F.3 Changes to Chapter II (Project Description)

Candlestick Point — Hunters Point Shipyard Phase II EIR

Page II-12, Figure II-5 (Proposed Maximum Building Heights) has been revised

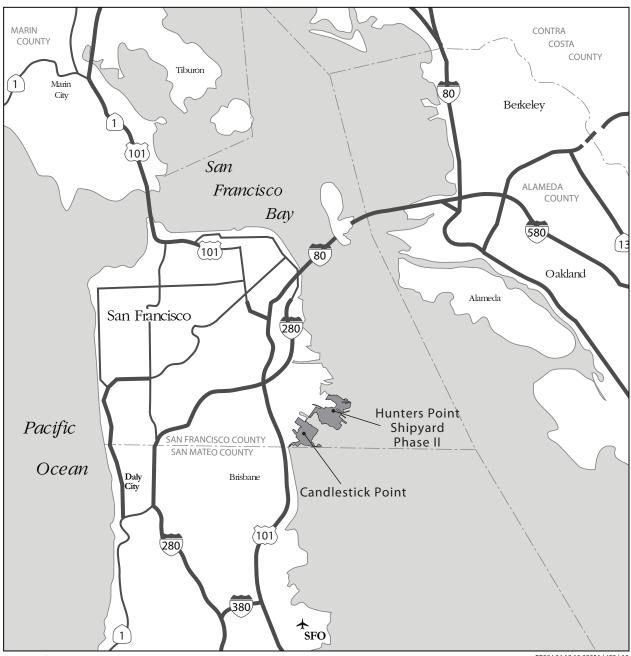
NOTE: The figure has been revised to identify major roadways.

Page II-27, Figure II-9 (Proposed Parks and Open Space) has been revised

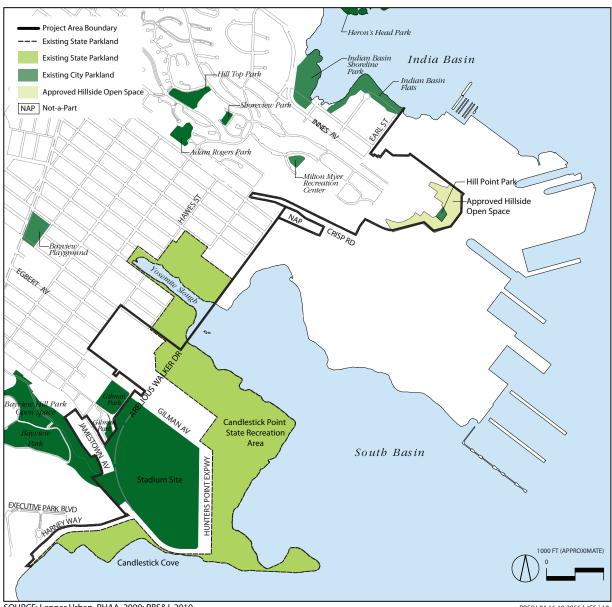
[NOTE: The figure has been revised to show the Bay Trail in the preferred alignment along the Yosemite Slough shoreline. The figure has also been revised to add "Approved" to Hillside Parks & Open Space; and to expand the boundaries of Gilman Park and Bayview Hill Park Open Space.]

Page II-29, Figure II-10 (Proposed CPSRA Reconfiguration) has been revised

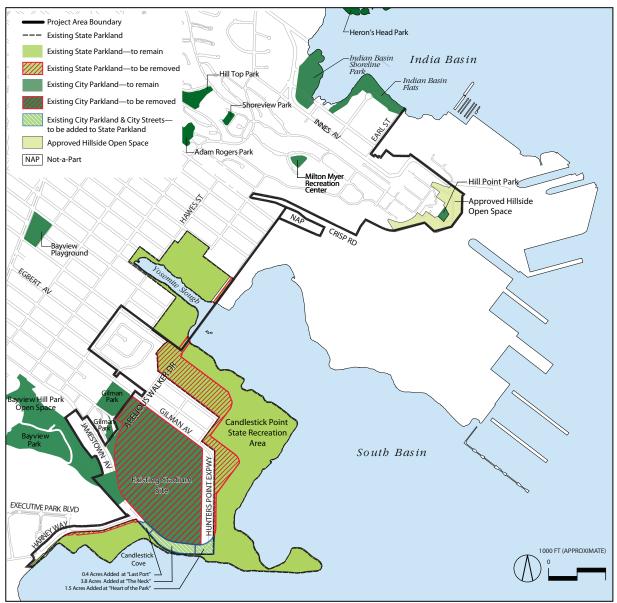
[NOTE: The figure has been revised to add "Approved" to Hillside Parks & Open Space; and to expand the boundaries of Gilman Park and Bayview Hill Park Open Space.]

Page II-52, Figure II-17 (Proposed Building and Parks Construction Schedule) has been revised

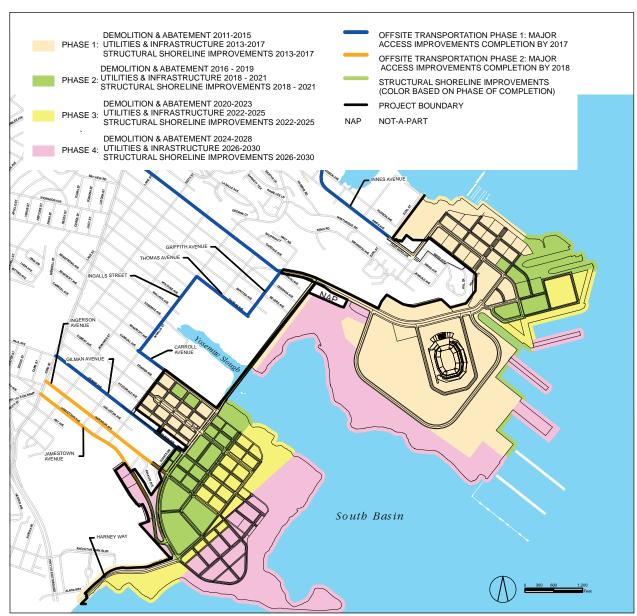
[NOTE: The figure has been revised to indicate that building construction activities will commence 1 to 2 years later than originally planned. The note * Dates Subject to Change has been added.]

Page III.A-8, Figure III.A-1 (Cumulative Development in the Project Vicinity) has been revised

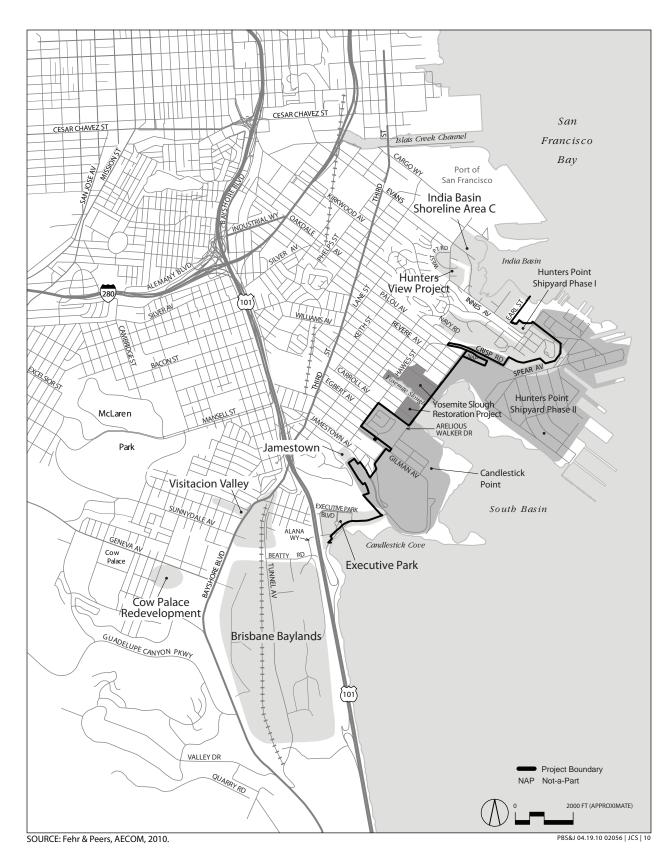
NOTE: The figure has been revised to add Yosemite Slough Restoration Project.]

Page III.B-3, Figure III.B-1 (Existing Land Use) has been revised

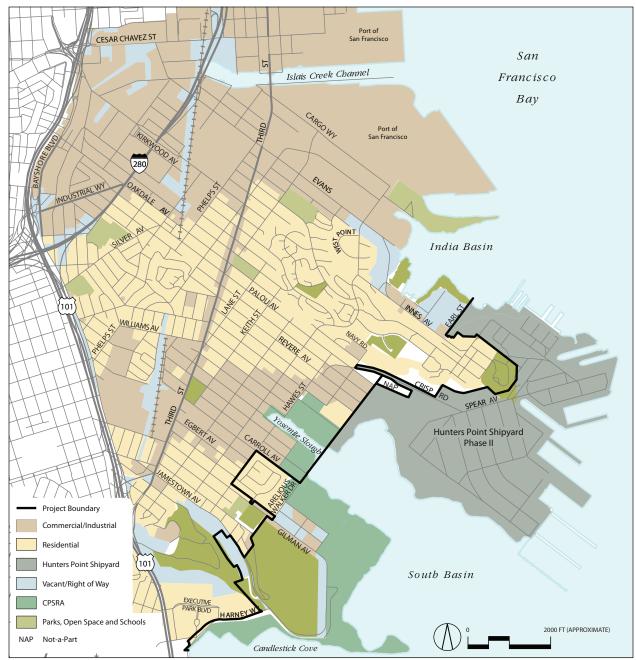
NOTE: The figure has been revised to switch the label colors between Residential and Commercial/Industrial.

Page III.B-18, Figure III.B-3 (Existing San Francisco Bay Trail Route) has been revised

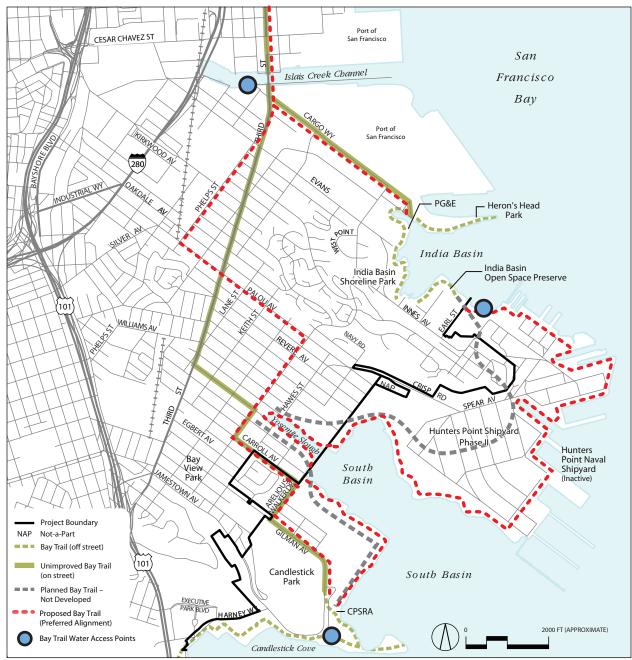
[NOTE: The figure has been revised to include Bay Area Water Trail access points in the Project vicinity; and to show the Bay Trail in the preferred alignment along the Yosemite Slough shoreline.]

Page III.E-23, Figure III.E-10 (Viewpoint Locations) has been revised

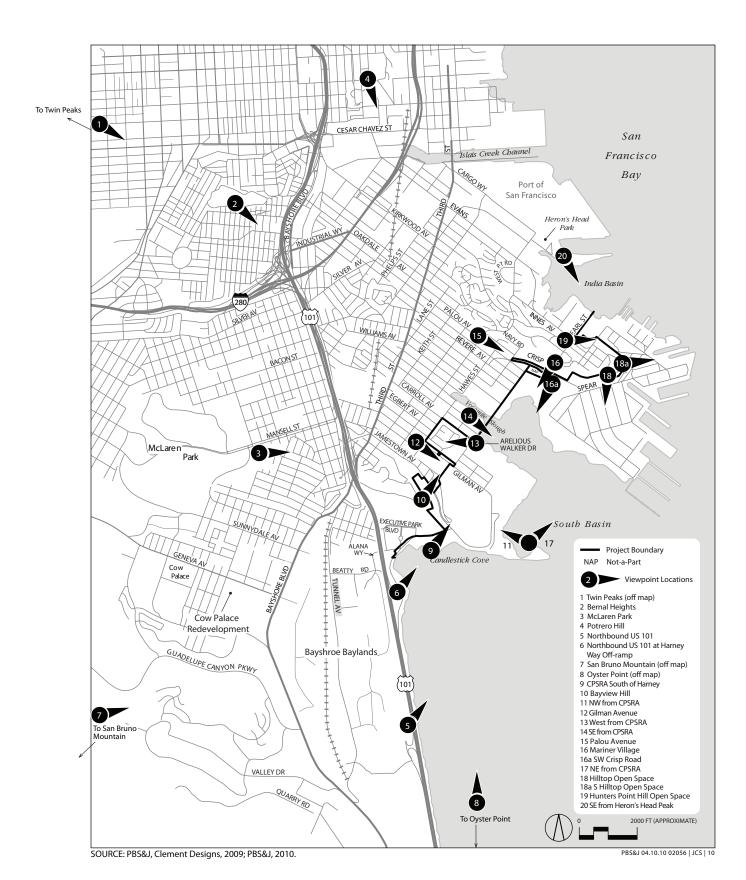
NOTE: The figure has been revised to add viewpoint locations #16a and #18a.]

Page III.K-26, new Figure III.K-6 (Status of CERCLA Process) is added

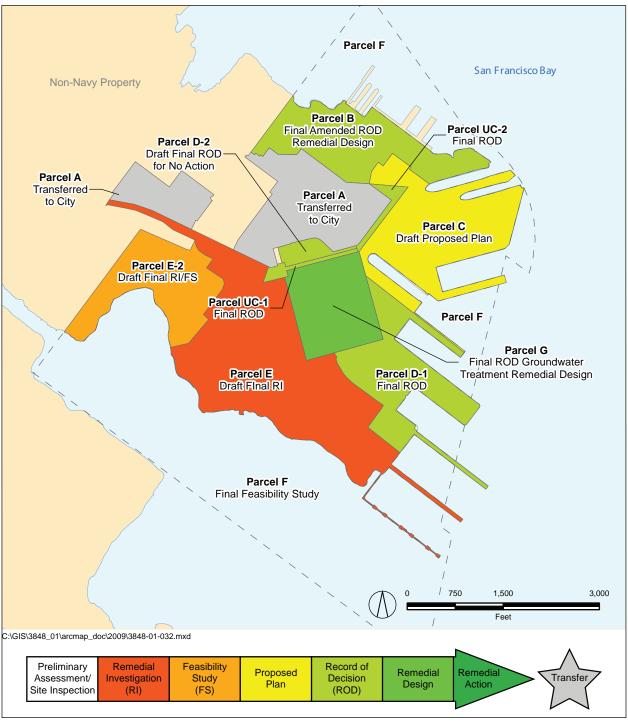
[NOTE: The figure has been added to illustrate the steps in the CERCLA process and the current status of the parcels in the process.]

Page III.K-51, Figure III.K-5 (Hunters Point Shipyard Phase II Navy Parcel Overlay) has been revised

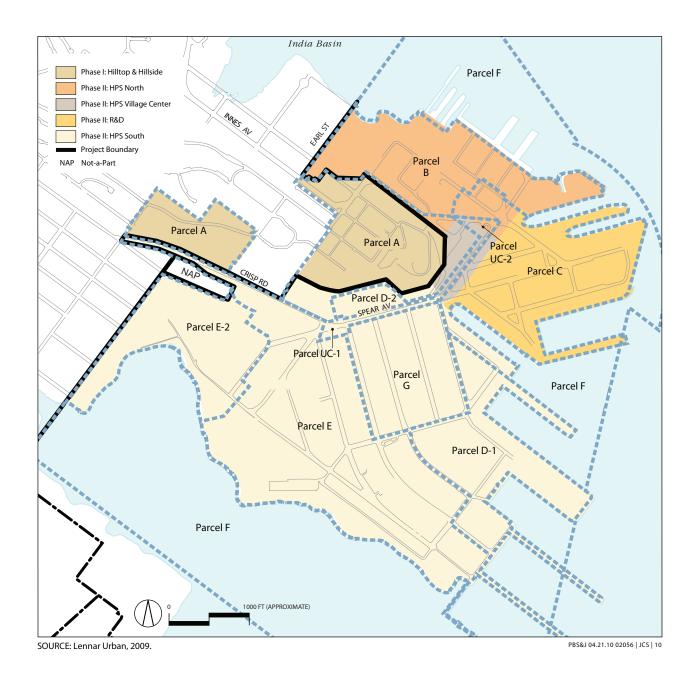
[The figure has been revised to show Parcel A' and Parcel A-3 as Parcel A; and a portion of Parcel B as Parcel C.]

Page III.N-122, new Figure III.N-7 (Impacts to Wetlands and Other Waters after Yosemite Slough Wetland Restoration) has been added after page III.N-121

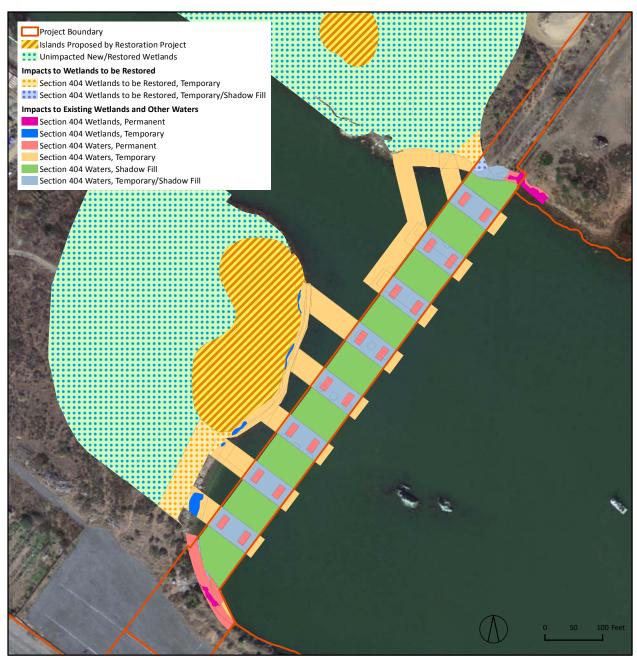
NOTE: The figure has been added to identify post-Yosemite Slough Restoration Project impacts.]

Page III.P-3, Figure III.P-1 (Existing and Approved Parks and Open Space) has been revised

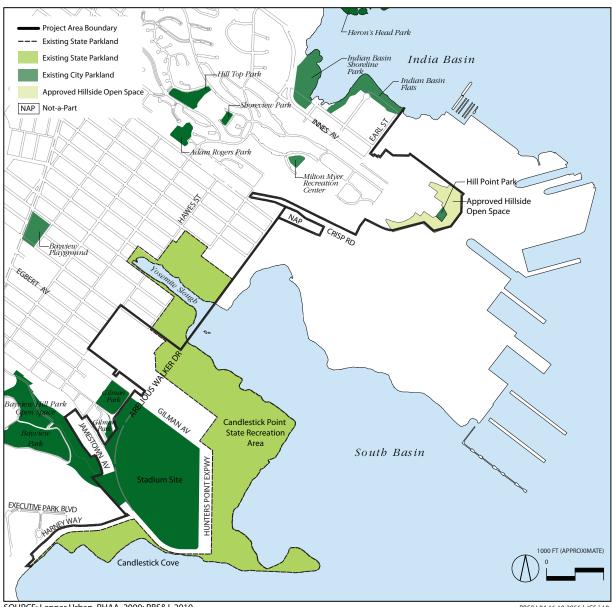
[NOTE: The figure has been revised to add "Approved" to Hillside Parks & Open Space; and to expand the boundaries of Gilman Park and Bayview Hill Park Open Space.]

Page III.P-18, Figure III.P-3 (Proposed CPSRA Reconfiguration) has been revised

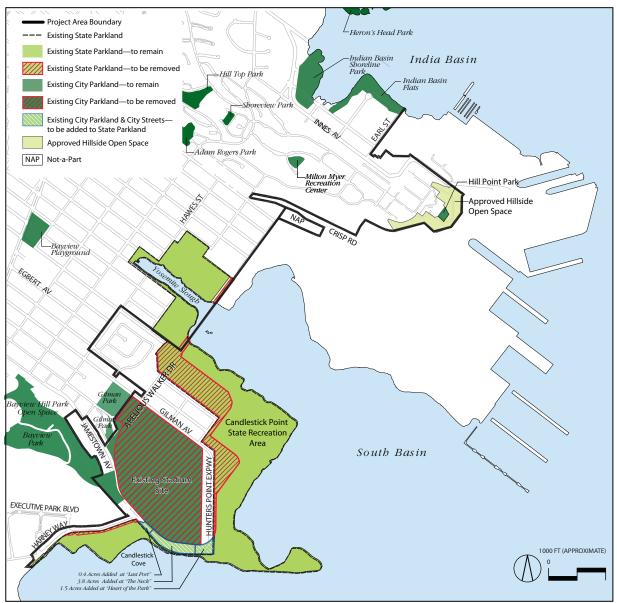
[NOTE: The figure has been revised to add "Approved" to Hillside Parks & Open Space; and to expand the boundaries of Gilman Park and Bayview Hill Park Open Space.]

Page IV-13, Figure IV-4 (R&D Variant [Variant 1] Building and Park Construction Schedule) has been revised

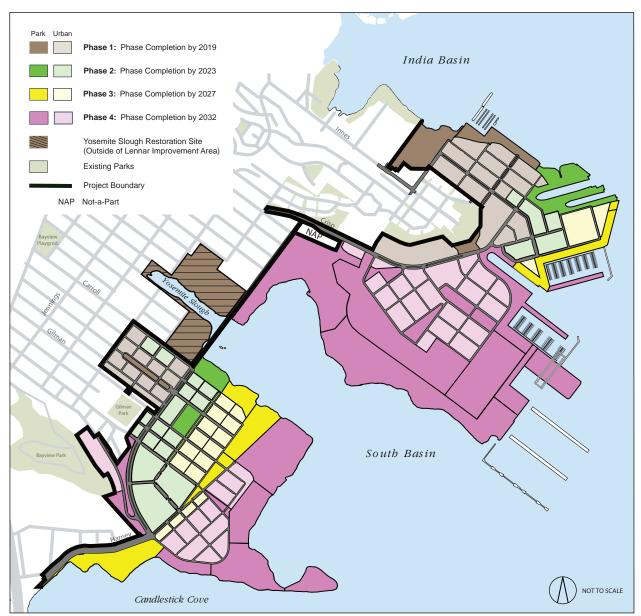
NOTE: The figure has been revised to indicate building construction activities starting 1 to 2 years later than originally planned.]
